Access Compliance Report

Public Rights-of-Way

Intersection ID: 42371	Main Street: HIGHLAND_CREEK_PY	Cross Street: CHRISTENBURY_RD	Location: SE
ADA ID: 9A77D2A2753C	Ramp Type: PerpDiag	Initial Pass/Fail: Fail	Overall Compliance: No
		Severity Score: 12.5

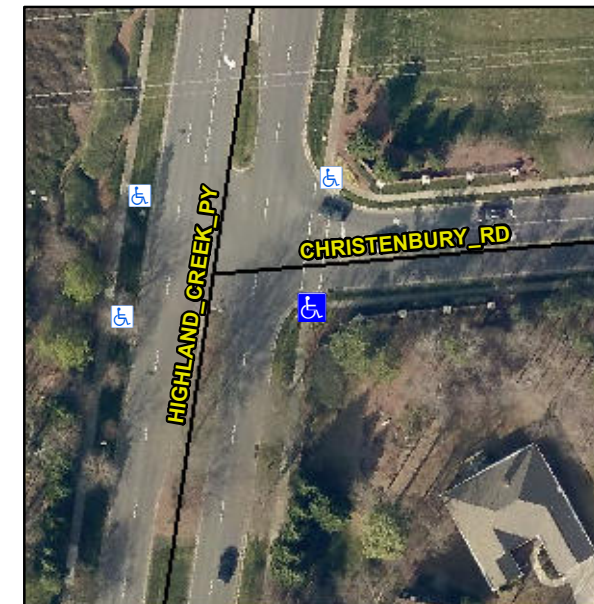
R304.2.2

Compliance	Description	Data	Compliance	Description	Data
N/A	Ramp Length (in)	58.0	No	Ramp Slope (%)	9.4
Yes	Ramp Width (in)	54.0	Yes	Ramp XSlope (%)	1.6
N/A	Flare Type LT	N/A	N/A	Flare Type RT	N/A
N/A	Flare Slope LT (%)	N/A	N/A	Flare Slope RT (%)	N/A
N/A	Flare Traversable LT?	N/A	N/A	Flare Traversable RT?	N/A
N/A	Landing Length (in)	N/A	N/A	DWS Provided?	N/A
N/A	Landing Width (in)	N/A	N/A	DWS Contrast?	N/A
N/A	Landing Slope (%)	N/A	N/A	DWS Length (in)	N/A
N/A	Landing X Slope (%)	N/A	N/A	DWS Full Width?	N/A
N/A	Landing Curb? (Y/N)	N/A	N/A	DWS Offset (in)	N/A
N/A	Shared Landing?	N/A			
N/A	Gutter Ponding?	N/A	N/A	Gutter Slope (%)	N/A
N/A	Gutter Lip Ht (in)	N/A	N/A	Gutter X Slope (%)	N/A
N/A	Painted X Walk1?	Yes	N/A	Painted X Walk2?	No
	X Walk 1 Direction	To N		X Walk 2 Direction	To W
N/A	X Walk 1 Width (in)	106.0	N/A	X Walk 2 Width (in)	N/A
	X Walk 1 Slope (%)	1.6		X Walk 2 Slope (%)	3.4
	X Walk 1 X Slope (%)	2.1		X Walk 2 X Slope (%)	1.3

Remove & Replace Curb Ramp With Two New Directional Ramps or Equivalent.
